Item Name: Crosstube, Low Narrow Aft, 412CF

Sequence ID/ Work Center ID	Operation Description	Set Up/ Run Hours	Tool ID	Tool #	Plan Code	Accept Qty	Reject Qty	Reject Number	Insp. Stamp
Draw Nbr	Revision Nbr								
D412-664-245	Rev D/DEO								
100		0.00							
100	DOCUMENT CONTROL								
DC	Memo	0.00							
Document Control	Photocopy bluefile and create labels as per PPP D412-664-205 CHG004								
110		0.00							
110	Packaging								
Packaging	Memo	0.00							
Packaging									
120		0.00							
120	BENDING MACHINE - CROSSTUBES								
CNC Bend 2	Memo	0.00							
CNC Alpha 160 Bender	Bend tube as per Dwg D412-664-243 using CNC bender program 412-af and Folio FT010

DRAWING NO. D412-664-245		TITLE CROSSTUBE ASS'Y (412 LOW-N AFT)		REV. D DART AEROSPACE LTD ENGINEERING ORDER		D.E.O. NO. D412-664-245-D-1		SHEET NO. SHEET 1 OF 2		SCALE NTS	
DRAWN <i>qj</i>		CHECKED <i>SC</i>		MFG. APPR. <i>EL</i>		APPROVED <i>MP</i>		DE APPR. <i>MP</i>			
DATE 11.05.25		DATE 11.05.31		DATE 11.05.31		DATE 11/05/31		DATE 11.05.31

DRAWING NO. D412-664-245	TITLE CROSSTUBE ASS'Y (412 LOW-N AFT)	REV. D	DART AEROSPACE LTD ENGINEERING ORDER		D.E.O. NO. D412-664-245-D-2	SHEET NO. SHEET 1 OF 1	SCALE NTS
D

DRAWING NO. D412-664-245	TITLE CROSSTUBE ASS'Y (412 LOW-N AFT)	REV. D	DART AEROSPACE LTD ENGINEERING ORDER	D.E.O. NO. D412-664-245-D-3	SHEET NO. SHEET 2 OF 3	SCALE NTS
DRAWN 97	CHECKED	MFG. APPR.	APPROVED	DE APPR.		
DATE 12.08.21	DATE 12.08.27	DATE 12.08.29	DATE 12.08.29	DATE 12.08.29	DATE 12.08.29

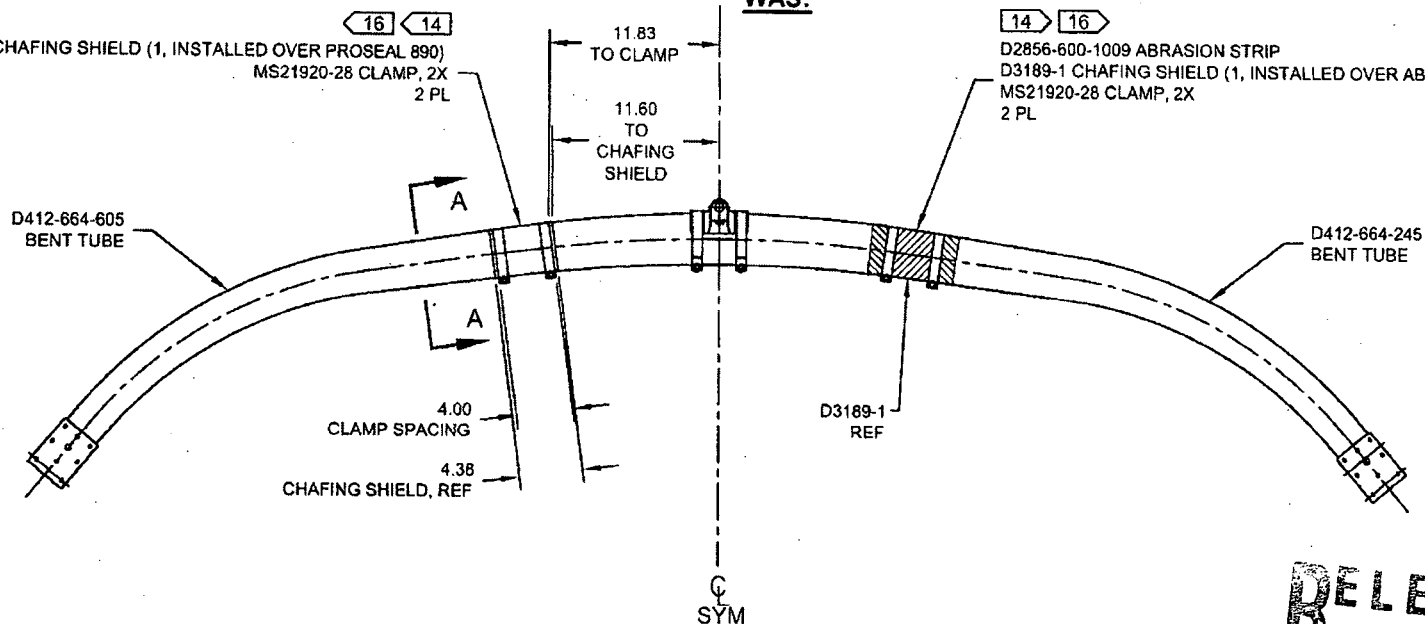
D3189-1 CHAFING SHIELD (1, INSTALLED OVER PROSEAL 890)
MS21920-28 CLAMP, 2X
2 PL

WAS:

D2856-600-1009 ABRASION STRIP
D3189-1 CHAFING SHIELD (1, INSTALLED OVER ABRASION STRIP)
MS21920-28 CLAMP, 2X
2 PL
